SR 405
BOTHELL TO SWAMP CREEK 1/3
HOV LANES - STAGE 1
TANKS AND VAULTS

LAYOUT - NW-12 VAULT

DETAIL OF TEMPORARY PAVEMENT 2/2

TYPICAL TRANSVERSE SECTION

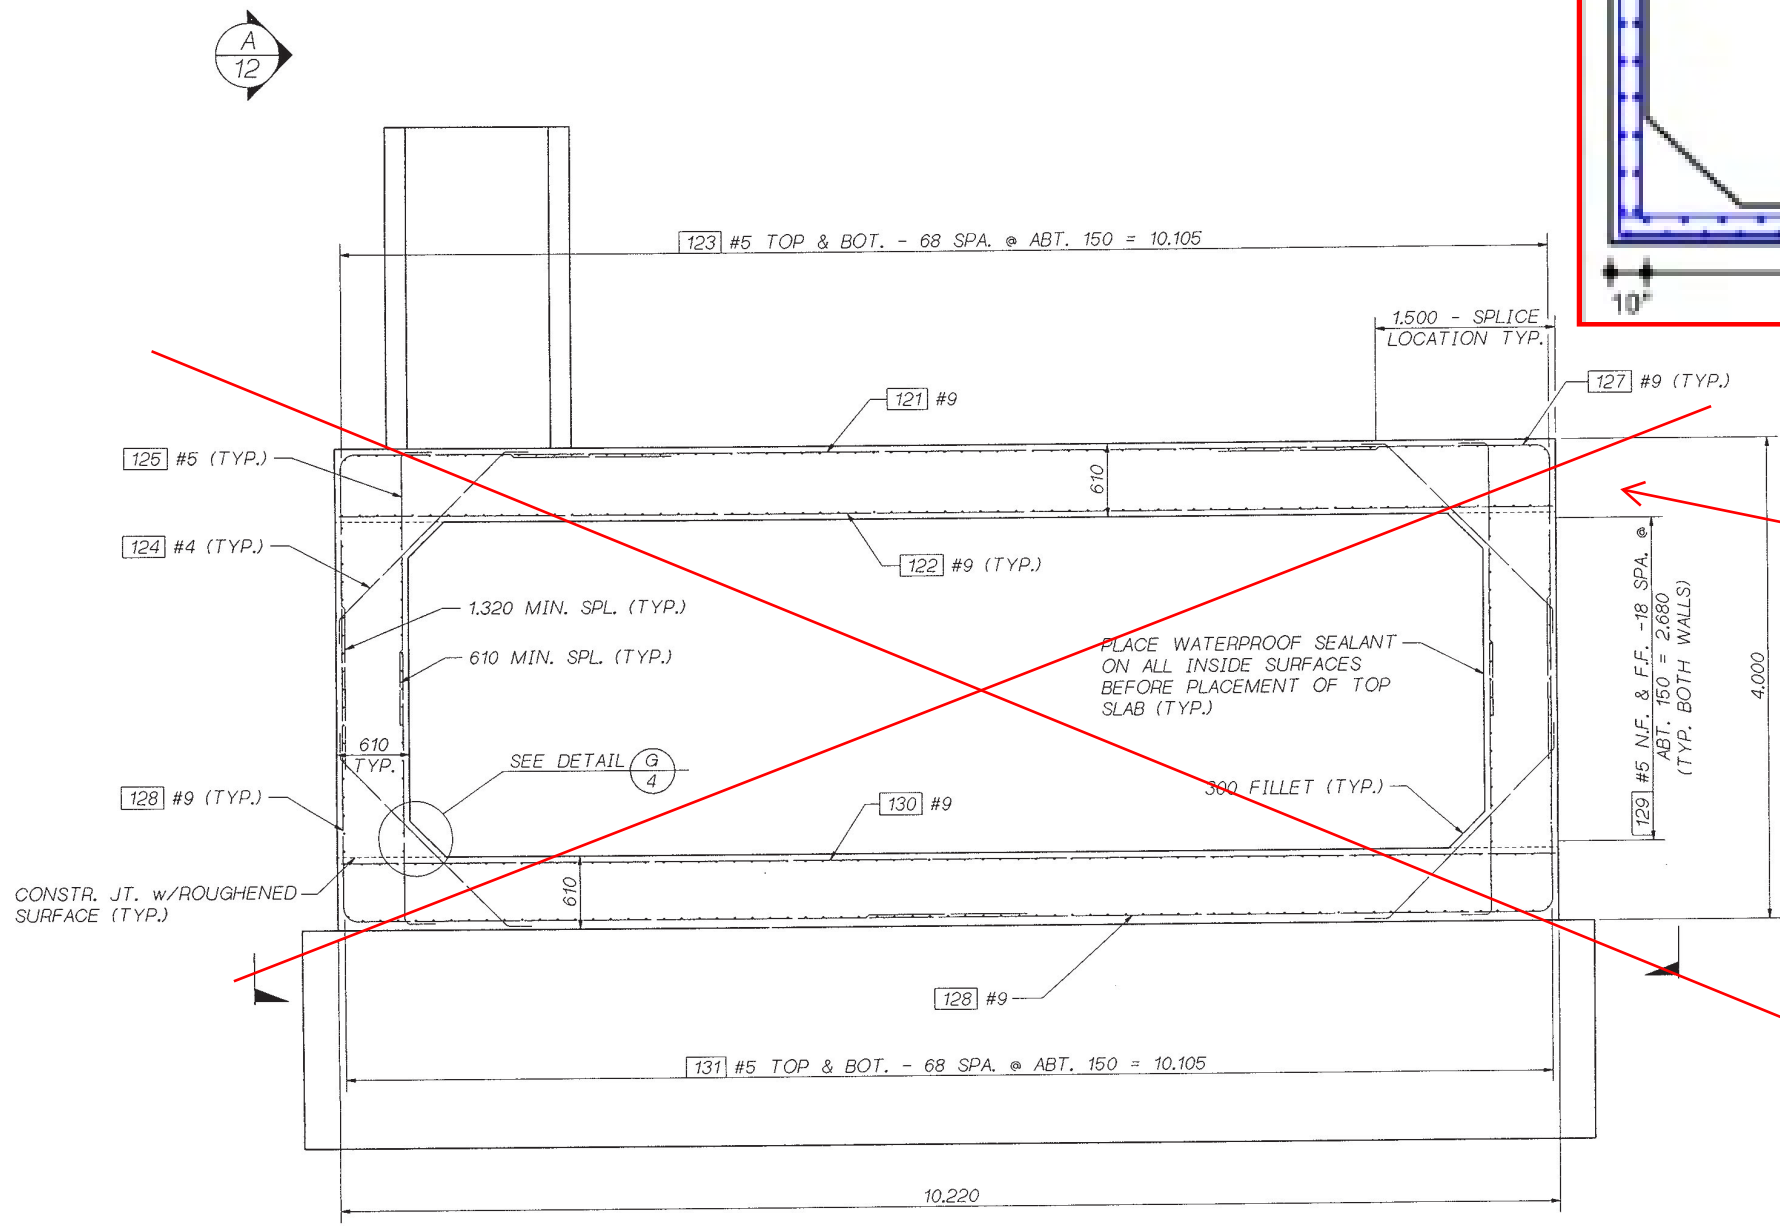
transverse-section is replaced with the section shown above and reinforcing as described below.

- Configuration and materials: Single-cell precast concrete box culvert
- Geometry: Interior dimensions are 20' wide x 9' high, with 2' chamfer at top and bottom. Wall and slab thicknesses are 10".
- Depth of fill above culvert: Varies from 4'-6'
- Reinforcement:
 - Top Slab - Interior: #7 bars at 5" o.c. transverse and #5 bars at 10" o.c. longitudinal
 - Wall - Interior: #5 bars at 5" o.c. vertical with #5 bars at 10" o.c. horizontal
 - Wall - Exterior: #7 bars at 5" o.c. vertical with #5 bars at 10" o.c. horizontal

TYPICAL LONGITUDINAL SECTION
- BAR LENGTH AND SPLICE LOCATION AT CONTRACTORS OPTION.

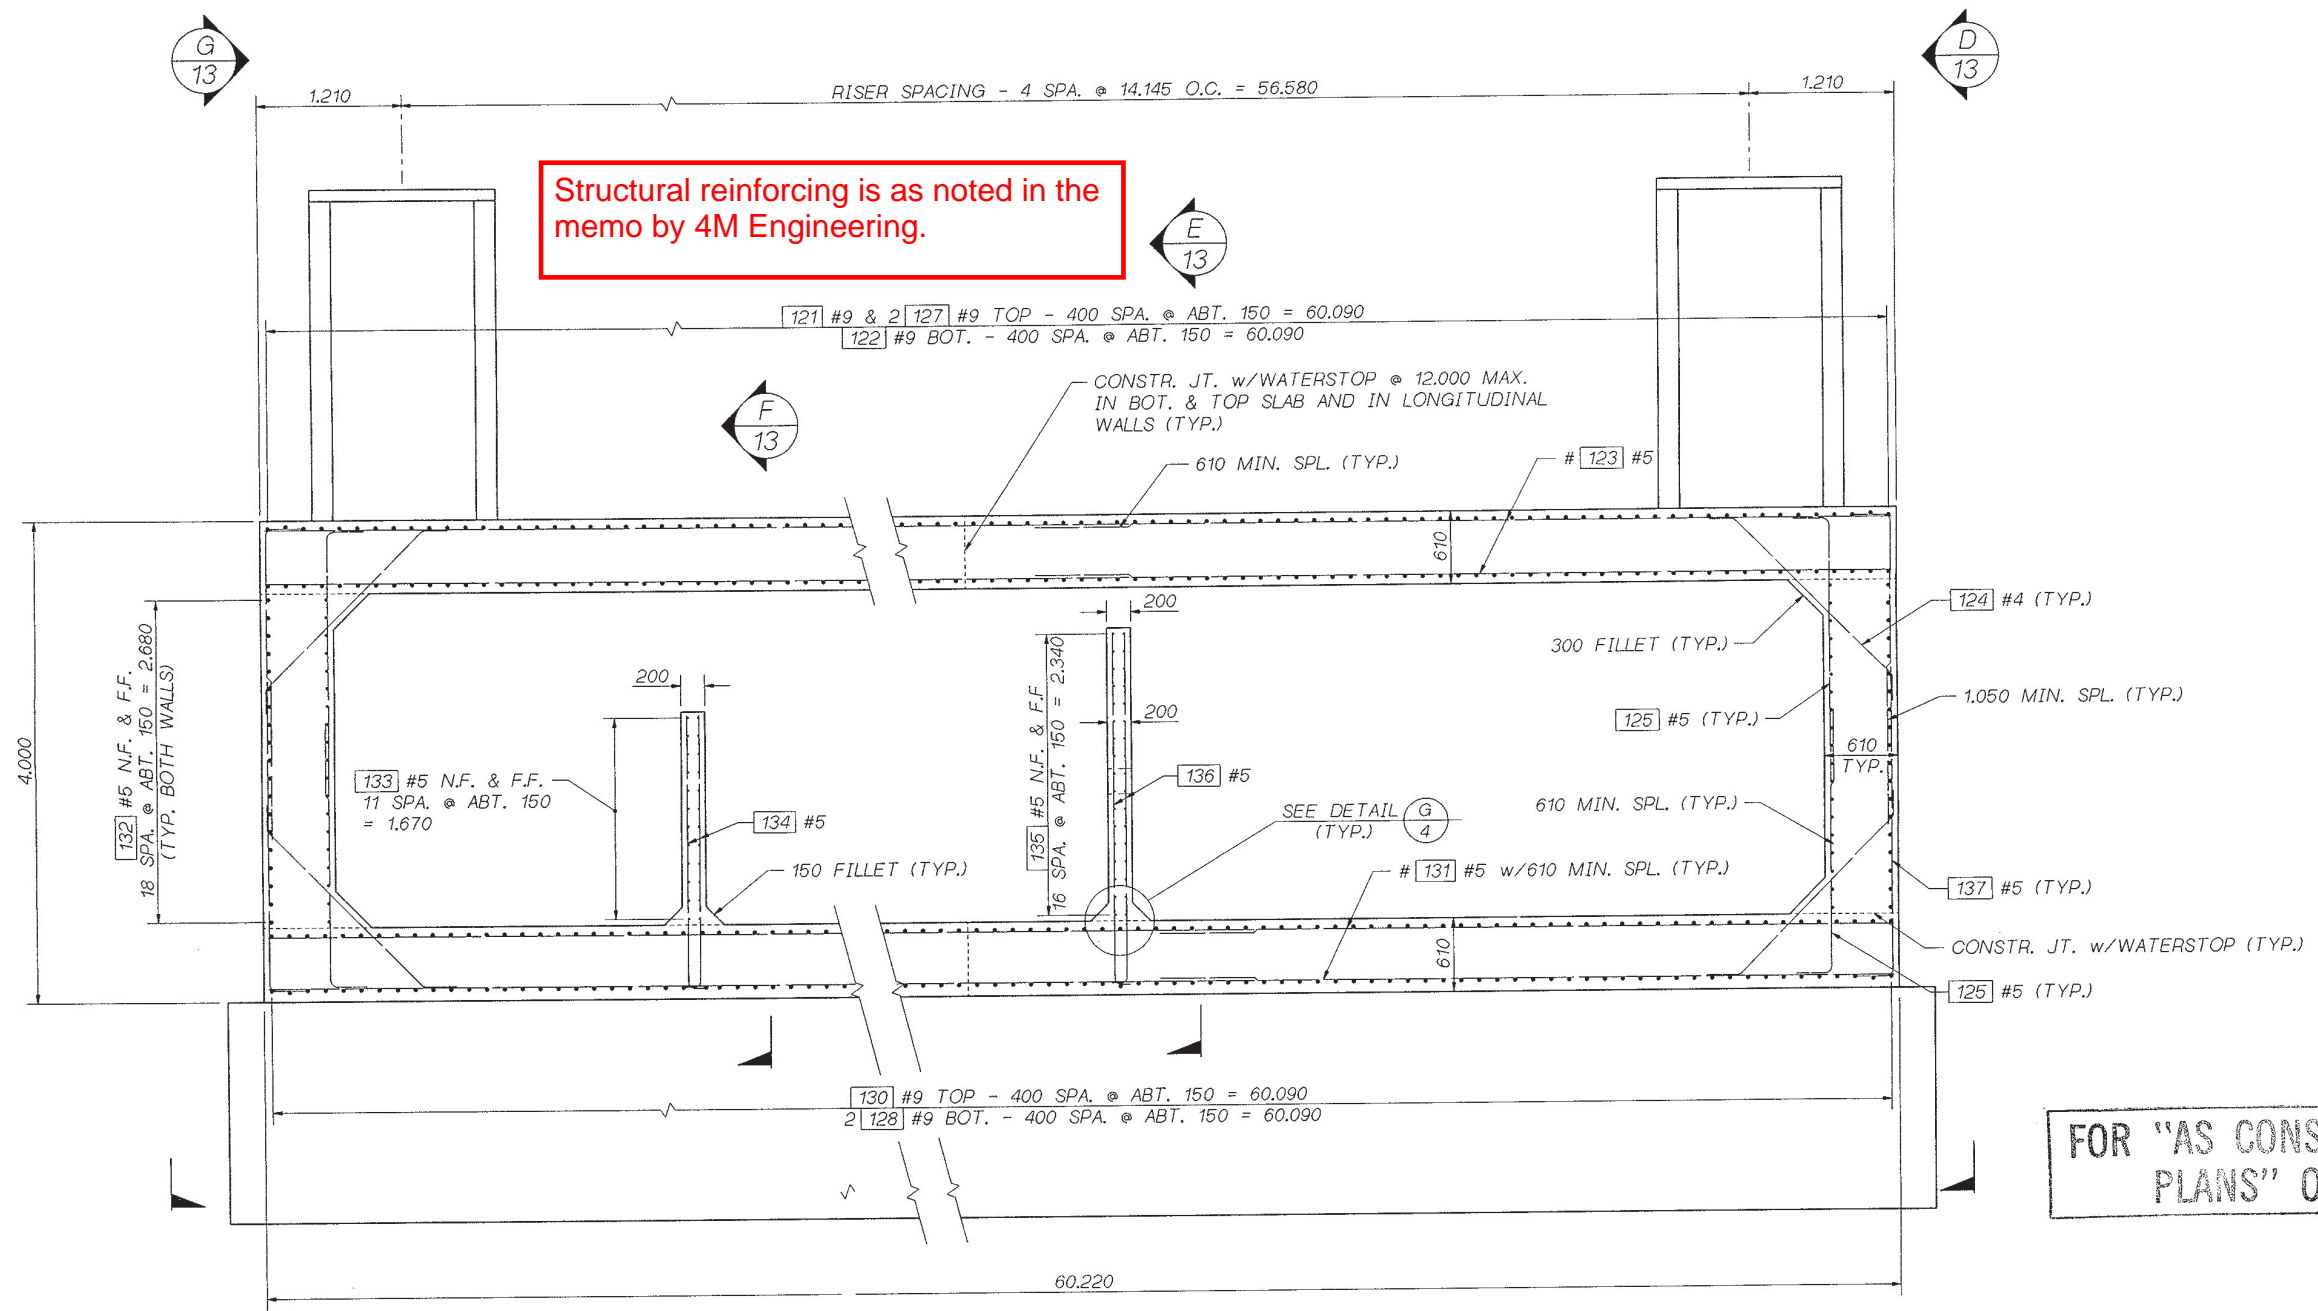
Structural reinforcing is as noted in the memo by 4M Engineering.
